## MCP45HVX1 Rev. A1 Silicon/Data Sheet Errata

The MCP45HVX1 parts that you have received conform functionally to the current device data sheet (DS20005304A) except for the anomalies described in this document.

FIGURE 1: General Call Formats.

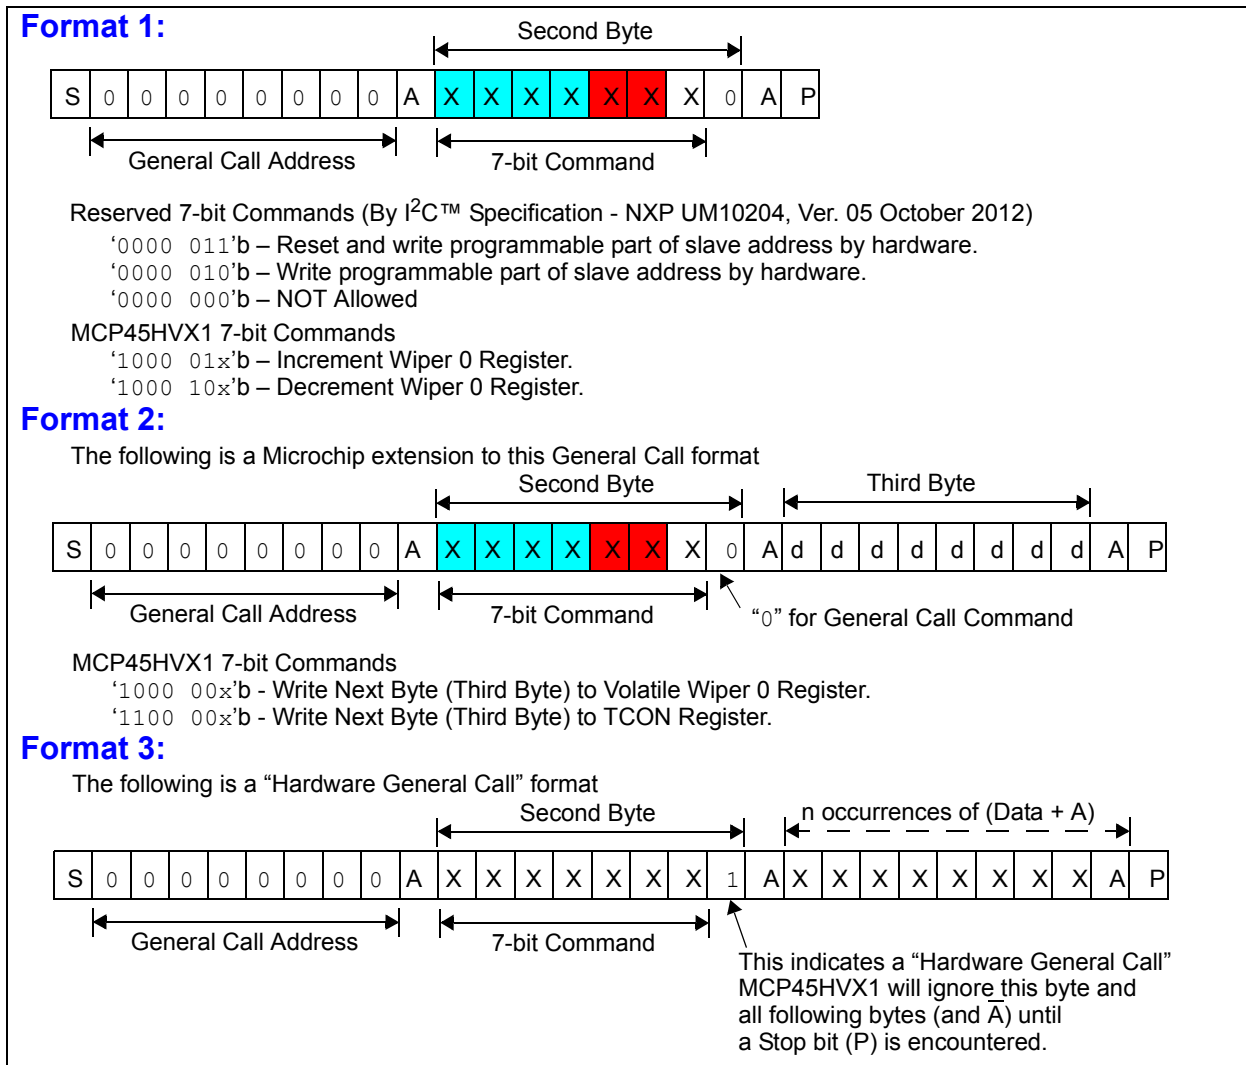
The I<sup>2</sup>C General Call command (see [Figure 1](#)) does not properly decode the four address bits (b7:b4) in the second byte with respect to the two command bits (b3:b2). If the received address is invalid for the specified command, then the device will use the address from the previous valid command received. If either of these addresses was a valid combination for the specified command, then the MCP45HVX1 will generate an ACK on this second byte and operate the command.

The I<sup>2</sup>C General Call command (see Figure 1) does not properly decode the Hardware General Call bit (b0) in the second byte. The device ignores the state of this bit, and responds according to the state of the previous seven bits.

If the second byte of the I<sup>2</sup>C General Call command is a different value than the three reserved commands or the four Microchip-specific commands, then the MCP45HVX1 device would need to be on a separate I<sup>2</sup>C bus where those commands would not occur.

None.
